**RESOLUTION NO. 2019 - 33  
LOWER PROVIDENCE TOWNSHIP**

**A RESOLUTION OF THE LOWER PROVIDENCE TOWNSHIP  
BOARD OF SUPERVISORS, MONTGOMERY COUNTY,  
PENNSYLVANIA, APPROVING THE PRELIMINARY/FINAL LAND  
DEVELOPMENT PLAN FOR IROY SPORTS FACILITY**

SUBJECT: **REVIEW COMMENTS – IROY SPORT & FITNESS**  
**PRELIM. / FINAL LAND DEVELOPMENT PLANS DATED REVISED 10-4-2019**

= PARKING ROWS WITH GREATER THAN 18 SPACES

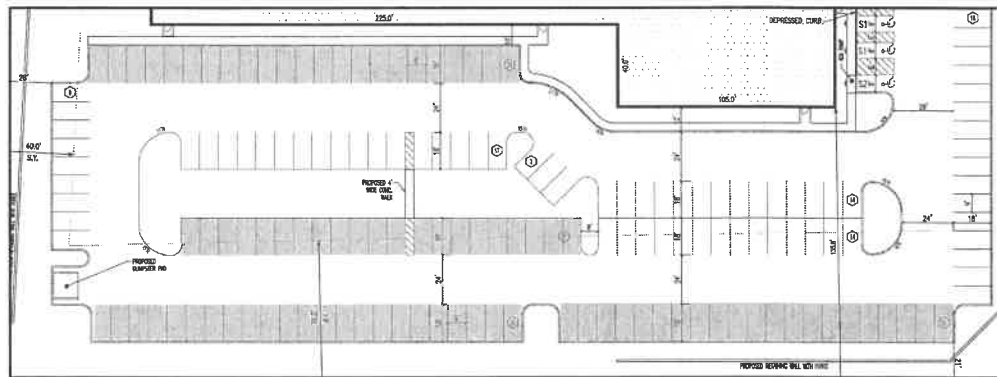
The **10-4-2019** Plan indicates the four (4) proposed rows of parking that exceed 18 parking spaces:

The Plan meets *exactly* the Zoning Ordinance requirement for 189 parking spaces. As such, compliance with §123-37.C (SLDO) could mean non-compliance with the parking space quantity requirement.

A Waiver has been requested accordingly from §123-37.C (SLDO).

Additional planted islands with trees would provide shade and aesthetic enhancement to the property. However, given the area constraints and minimum parking space requirement, we believe that approval of the requested Waiver should be based on whether the proposed configuration presents any circulation-related safety hazards. Therefore, we **still** defer to the Township Engineer and Transportation Engineer in making a recommendation pertaining to this Waiver request.

**(Per its 9-5-2019 Review Comments, the Township Traffic Engineer McMahon Associates, Inc. has no objection to the granting of this Waiver.)**
